**Re: Rohan Subdivision  
Lots 1P1 – 4-P1 Lot 17 Block 1 NAA Tract 3 Unit 3  
Grading & Drainage Plan  
Engineer's Stamp dated: 6-13-16 (C19D042A)**

Based upon the information provided in your resubmittal received 6/14/16, the above referenced Grading and Drainage Report and plan cannot be approved for Preliminary Plat, Grading Permit or Building Permit until the following comments are addressed:

**RE: Lots 1-P1 Thru 4-P1, Rohan Subdivision , File # C19D042A  
Grading and Drainage Plan, Responses to Comments Dated May 16<sup>th</sup>, 2016**

**RE: Lots 1-P1 Thru 4-P1, Rohan Subdivision , File # C19D042A  
Grading and Drainage Plan, Responses to Comments**

LOT 17 BASIN EXHIBIT

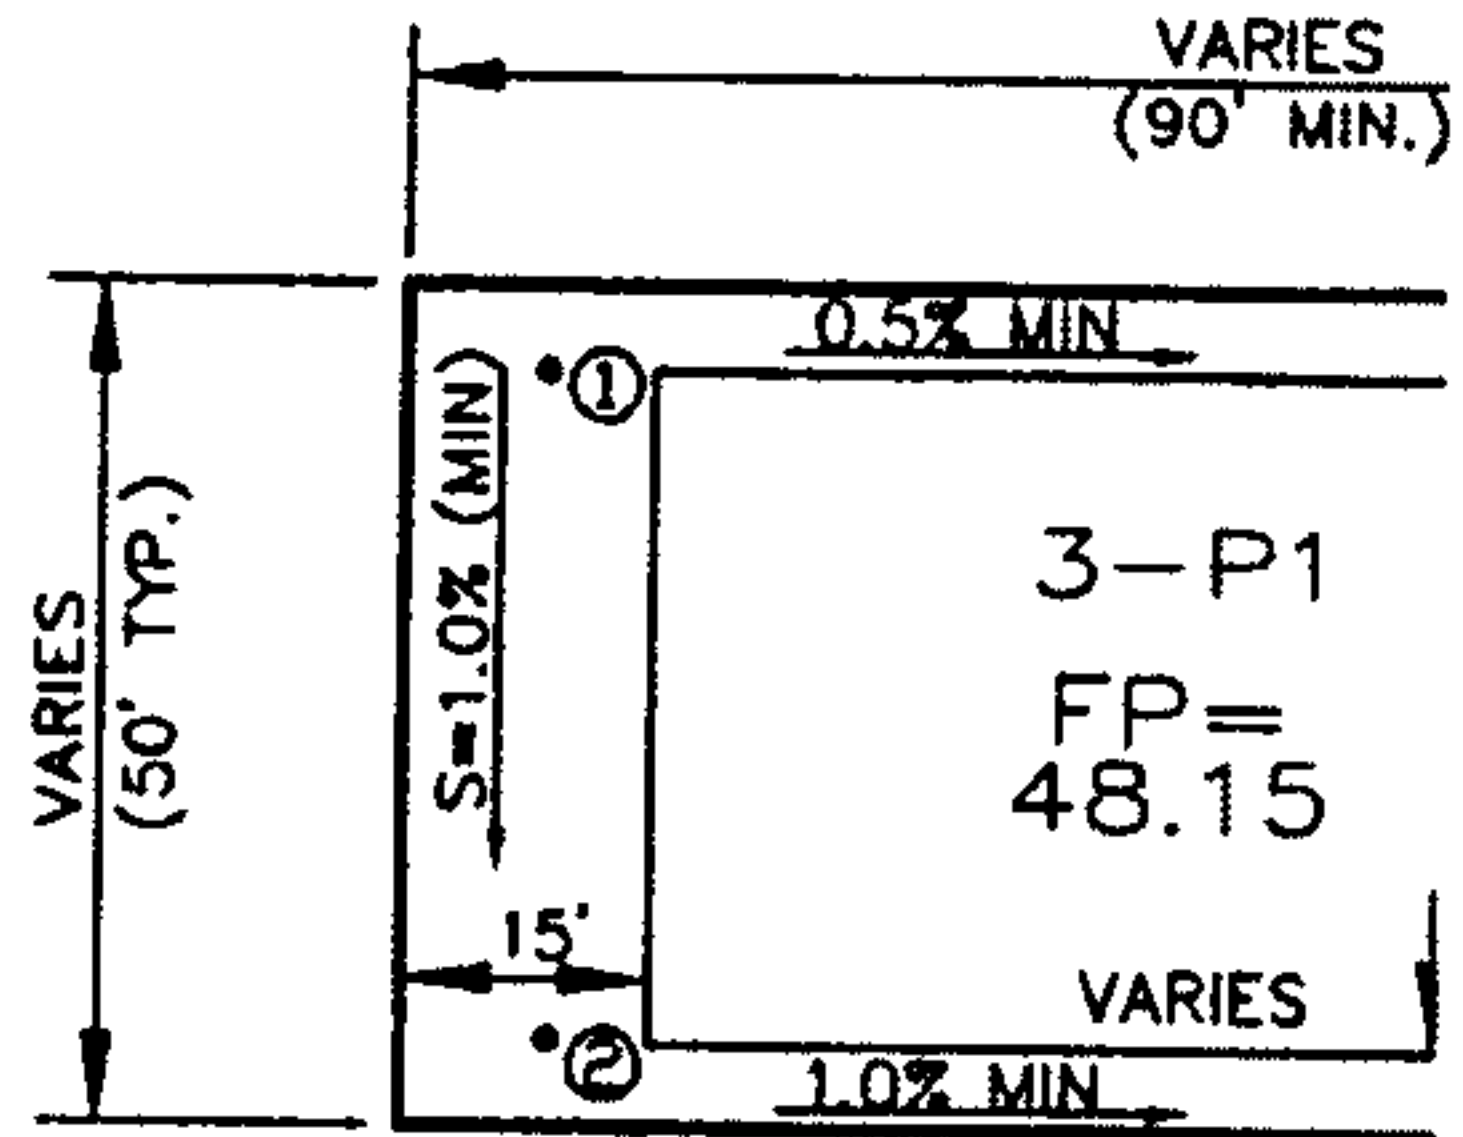
Not show extents of current Basin A

Show Basin A to Wyo

Core is 4' N not 5'

**TYPICAL LOT GRADING PLAN**

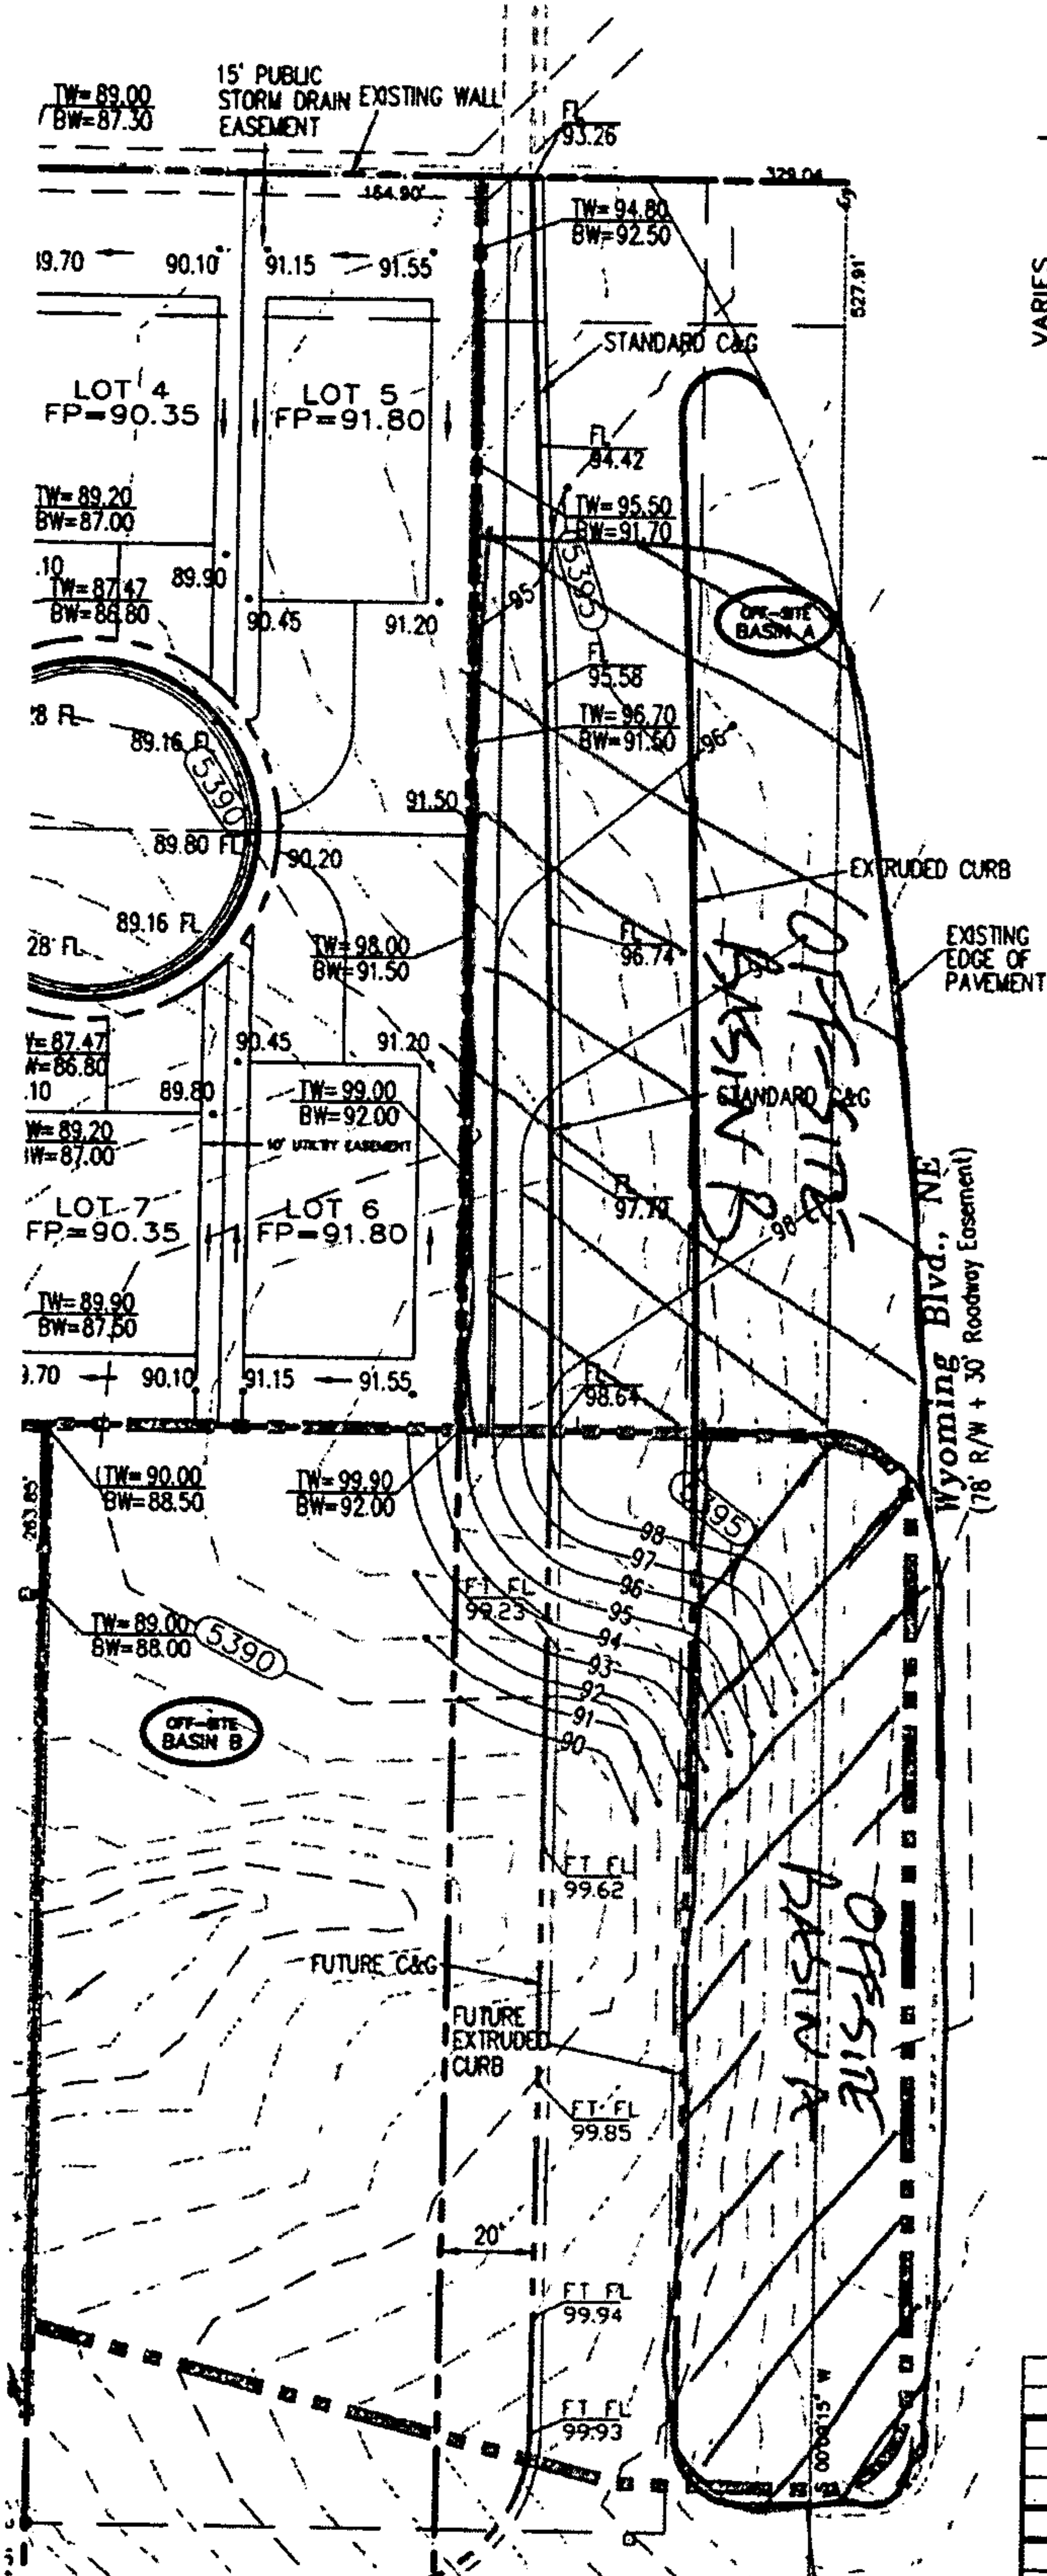
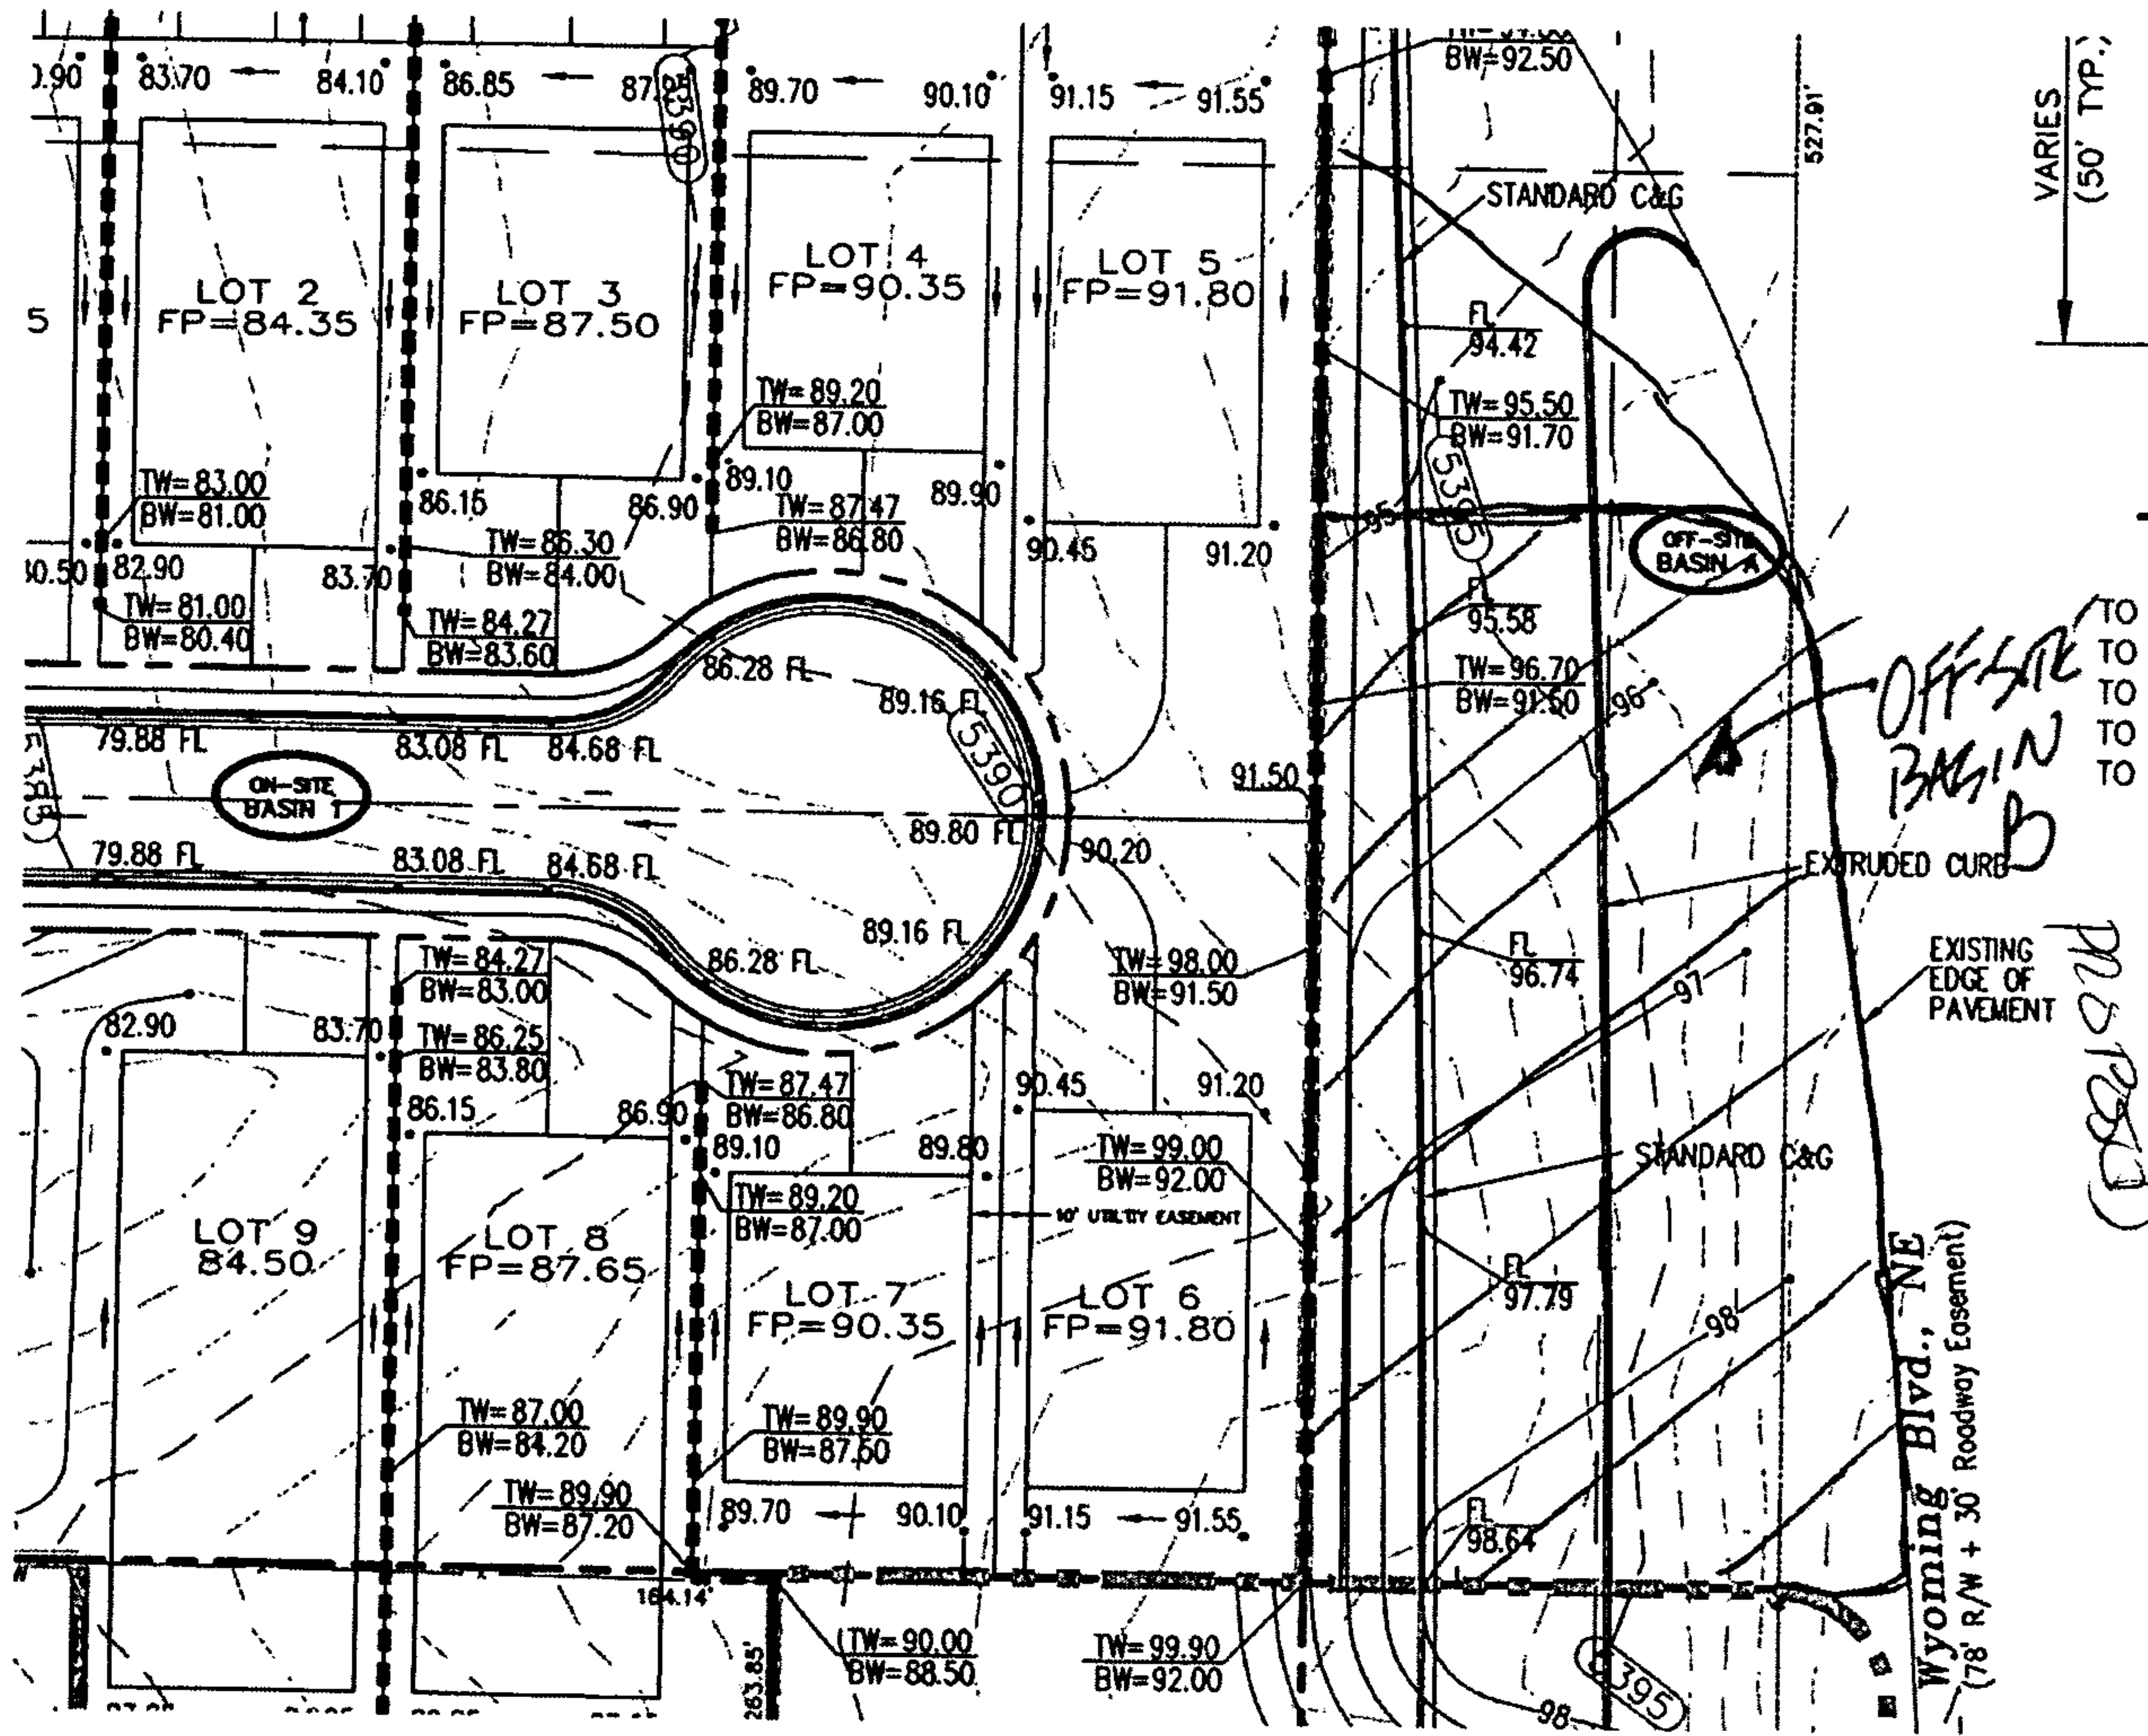
1. Show how the proposed grades around the perimeter of the lot will tie to existing ground.
  - a. East Perimeter: Basin A should be graded to drain to the swale; it appears that the east edge of the swale will be higher than existing ground.

- b. South Perimeter: Show elevations of the sidewalk that are consistent with the future vertical alignment of the Eagle Rock sidewalk (Sheet 2 shows that the future sidewalk ties to the proposed interim sidewalk).

- c. Driveway: The spot elevations of the driveway don't match the roadway elevations.
  - d. West Perimeter: Provide a section along the retaining wall to clarify the intent to provide positive drainage away from the wall, or if any fill is needed.

2. Ensure that the NE wall opening is aligned with the low spot, which appears to be at the corner of the Lot 6 & Lot 17 lot line intersection; or show grading that conveys flows to that point. Coordinate the possible need for an easement since the site will be accepting flows from the Wyoming Blvd Right of Way.

3. Provide a roadway edge (curbing or wall) along the west edge of the access easement between the retaining wall and the driveway.
